APPLICATION FOR ERECTION OF BUILDINGS.

EAST 11<sup>th</sup> ST.

BUILDING NOTICE

State proposed work in detail: to construct two water closet compartments on each of the 2nd, 3rd, 4th and 5th floors, one front and one rear and one additional water closet compartment on 1st flr. rear, all with metal ventilating ducts.

AMENDMENT

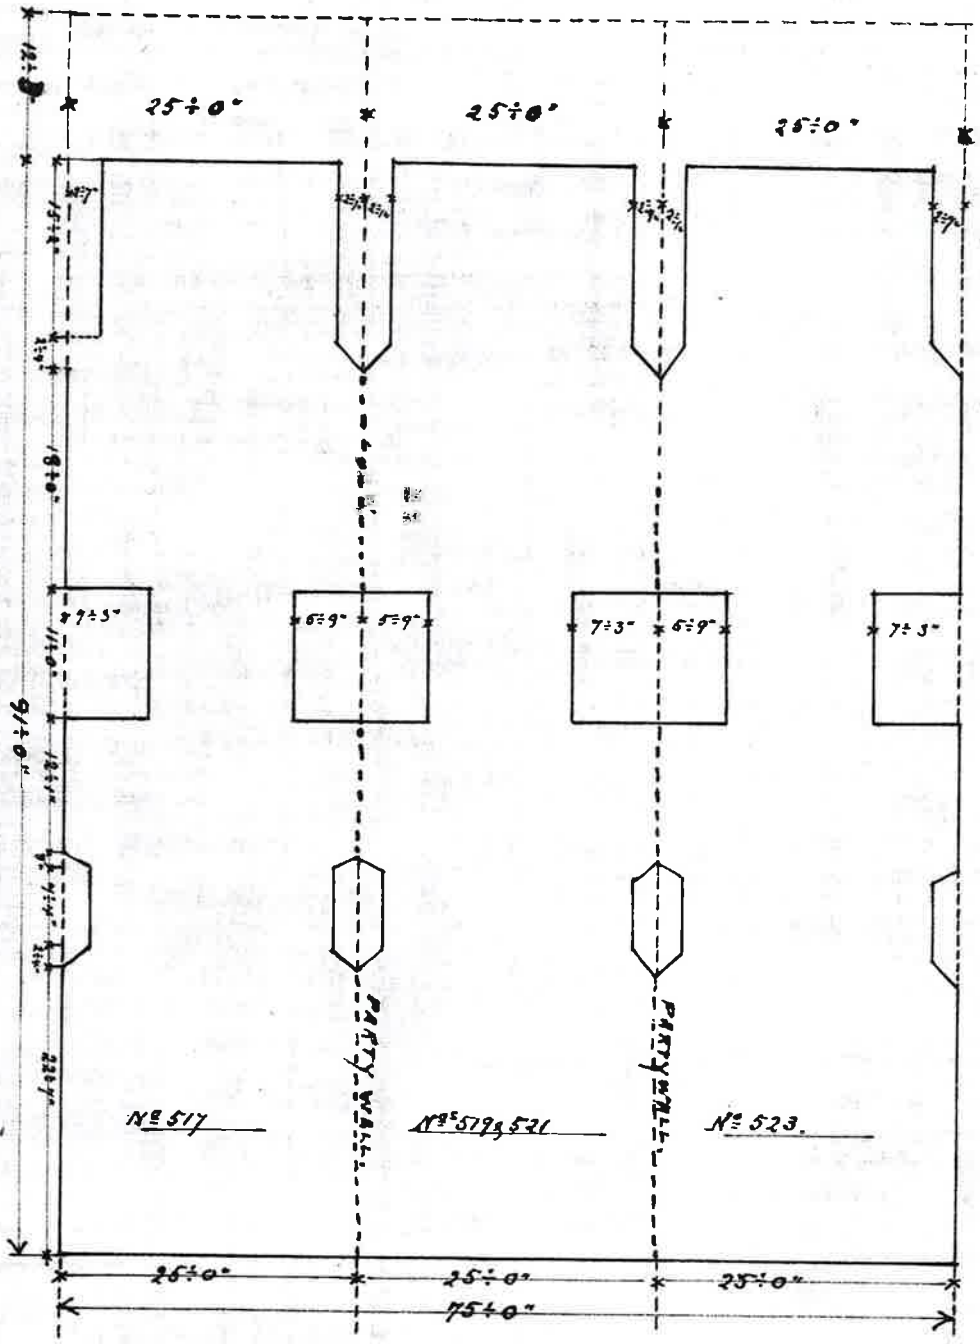
New plan herewith filed showing the installation of an additional toilet and compartment in the first floor westerly store to agree with job conditions.

EXAMINED AND RECOMMENDED FOR APPROVAL ON 12-29-54 19 54 Joseph E. Sheridan Examiner  
APPROVED DEC 29 1954 19 \_\_\_\_\_  
Borough Superintendent
